Baxter Academy
Rufus Deering

PERMIT APPLICATION - TRAFFIC TRAFFIC MOVEMENT PERMIT, 23 M.R.S.A. § 704 - A

Date: August 20, 2013
RE: Level III Site Plan Review and Traffic Movement Permit
CBL: 042 A007001
App #: 2012-519
Project Address: 54 York Street

Project Name: Baxter Academy for Technology and Science Project ID: 2012-519
Address: 54 York Street CBL: 042 A 007
Applicant: Rufus Deering Lumber Company
Planner: Shukria Wiar

SHEET 3 OF 4

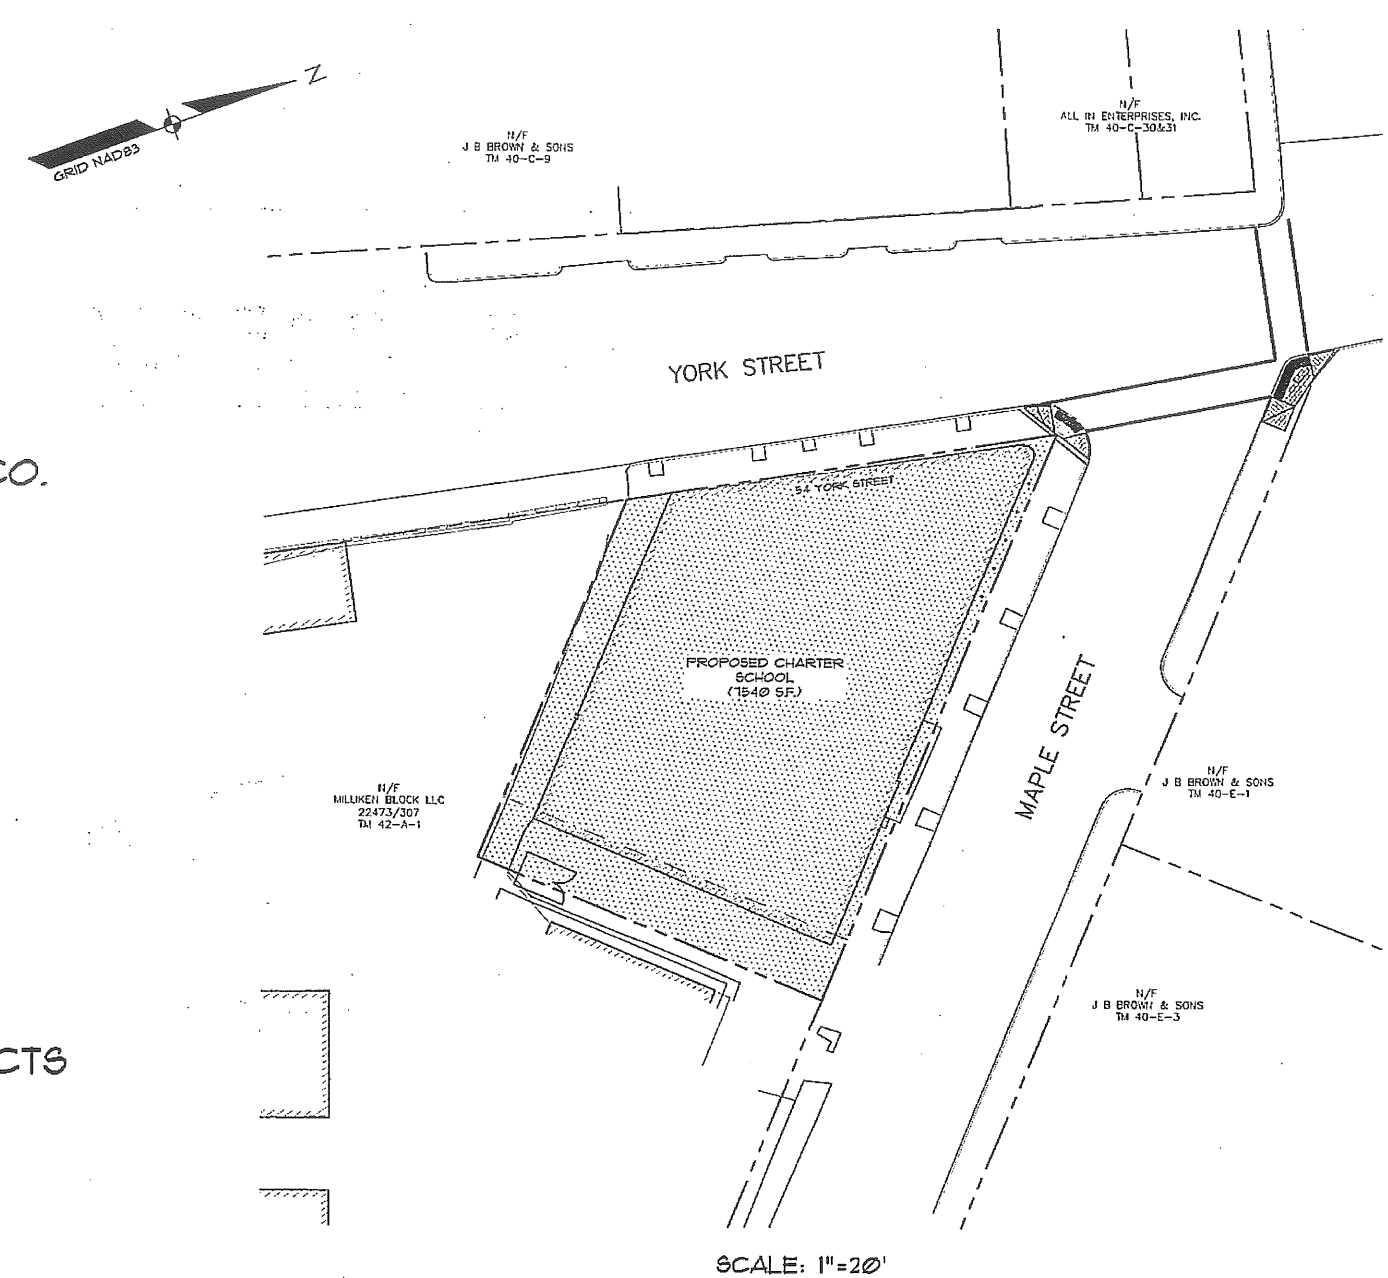
This morning, the city's Crosswalk Committee deliberated on the proposed curb ramp and crosswalk configurations as shown in the Baxter Academy site plan dated 12/14/12 per Sebago Technics (sheet 3 of 4). The Crosswalk Committee approves the new crosswalk across York Street on the west side of Maple Street, as shown. The Committee understood that there is to be new exterior lighting on the Baxter Academy building as well the existing exterior lighting on the Portland Pie building to adequately light the new crossing during the nighttime.
